NRO Staff Concerns About USAPWR Chapter 19 Material on Level 2 PRA and Severe Accident Evaluation

Office of New Reactors
February 2009

MAAP4 Calculations of Hydrogen / Helium Concentration in the Upper Dome, With and Without Subnodal Physics Model for Thermal Stratification (HDR E11.2 Hydrogen Mixing Experiment)

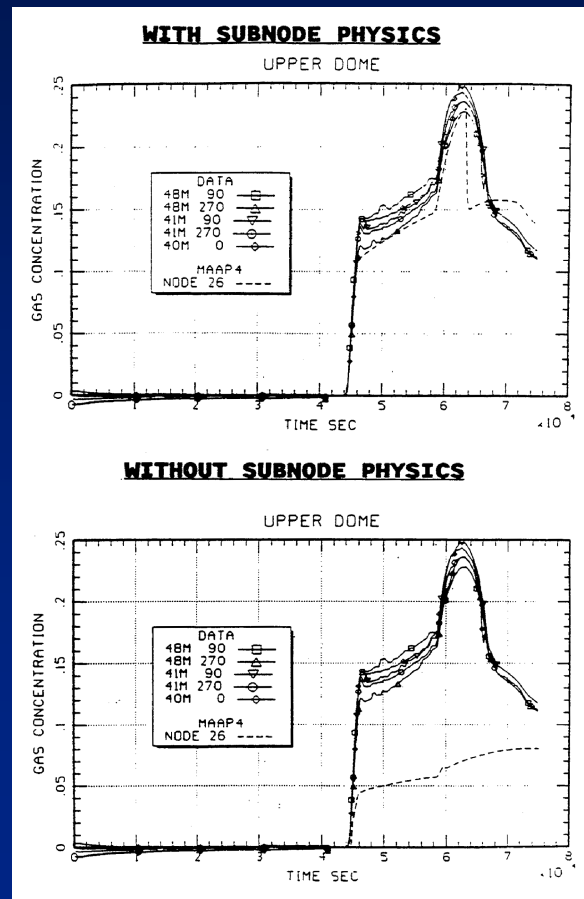
- Specifics of the GOTHIC code used for hydrogen distribution analyses, are not provided. Furthermore, reasons for not considering the MAAP information have not been provided.

- MAAP has been successfully benchmarked against HDR E11.2 test. We need to see a similarly successful benchmark for GOTHIC.
